Product Discontinuance Notification—PDN# PDN0000404641

We would like to inform you that Moxa is going to discontinue the PTC-101-M12 Series. This process will effectively begin March 15, 2024.

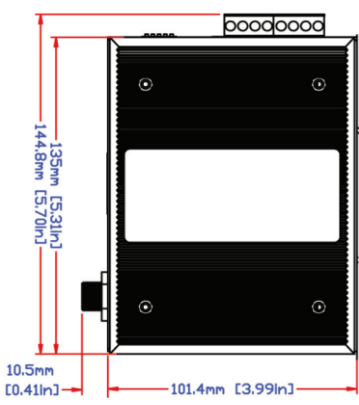
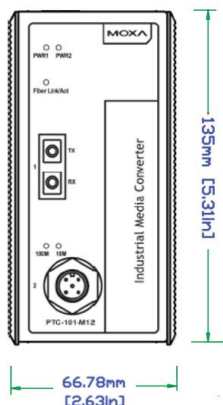
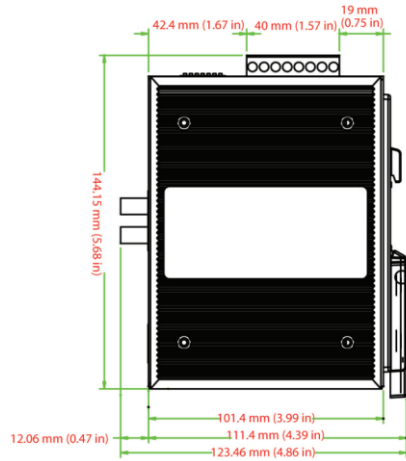
In this table, we list the difference in specifications between the discontinued products and the recommended replacement products.

Ethernet Port	M12 Type x 1	RJ-45 Type x 1
Input Voltage	20 to 72 VDC	Low Voltage models: 20 to 72 VDC
Railway	EN 50155, EN 50121-4	None
Safety	EN 60950-1, UL 60950-1	EN 62368-1, UL 62368-1, UL 60950-1
Dimensions	<p>Side View</p>  <p>Front View</p> 	<p>Side View</p>  <p>Front View</p>

Discontinued	Recommended Replacement	Available for Order
PTC-101-M12-S-SC-LV-T	PTC-101-S-SC-LV	Available Now
PTC-101-M12-S-ST-LV-T	PTC-101-S-ST-LV	
PTC-101-M12-S-SC-LV-CT-T ¹	PTC-101-S-SC-LV	
PTC-101-M12-S-ST-LV-CT-T ¹	PTC-101-S-ST-LV
